TYPE II LAND DIVISION & ENVIRONMENTAL REVIEW, STAFF REPORT & DECISION

Project Name: HILDMAN SHORT PLAT

Case Number: PLD2009-00003, SEP2009-00004, EVR2009-00002,
GEO2009-00004

Request: The applicant proposes to short plat approximately 15 acres into
3 residential lots in the Rural 5 (R-5) zoning district.

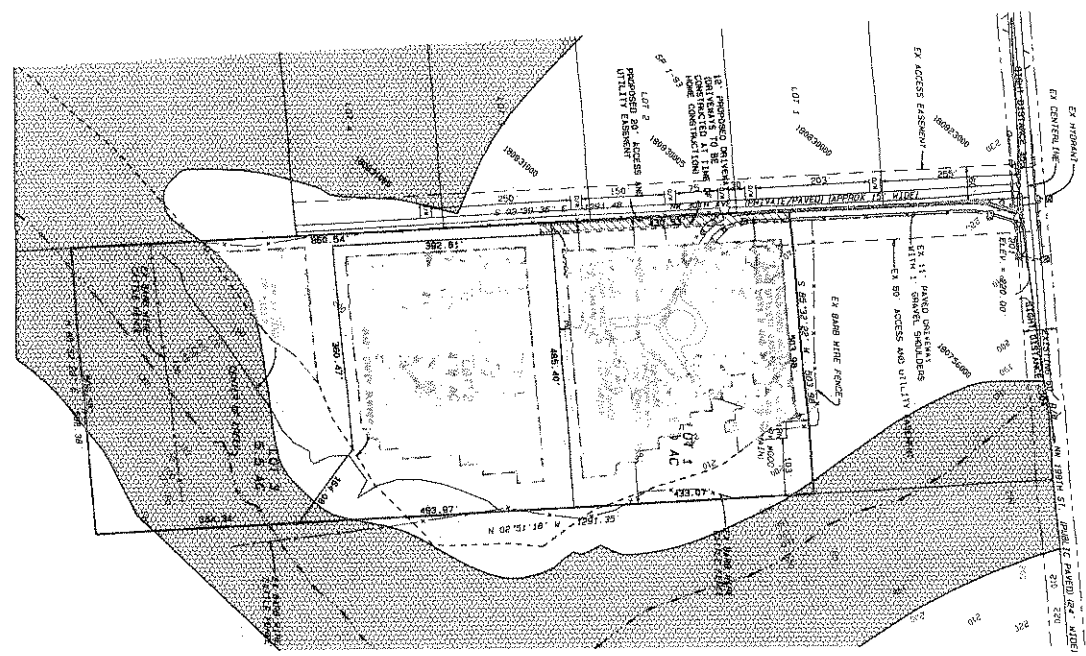
That applicant has proposed building envelopes that are outside of the riparian HCZ on the site. The proposed building envelopes comply with the exemption criterion identified in Table 40.440.010-1, row 2 of the Habitat Conservation Ordinance.

The site contains wetland areas associated with an on-site stream. The applicant has submitted a preliminary plat showing development envelopes that appear to avoid potential wetland and buffer areas. The development envelopes are sufficient to qualify the project for the waiver under CCC 40.450.030(G)(2). The project must comply with standard wetland conditions regarding physical demarcation, showing wetlands and buffers on the final plat, recording a conservation covenant, and adding a plat note that refers to the covenant. (See Conditions C-1a, D-7a, b, and D-10 f, g)

- a. The wetland and buffer boundaries shall be delineated on the face of the Final Plat. (See Wetland Finding 1)
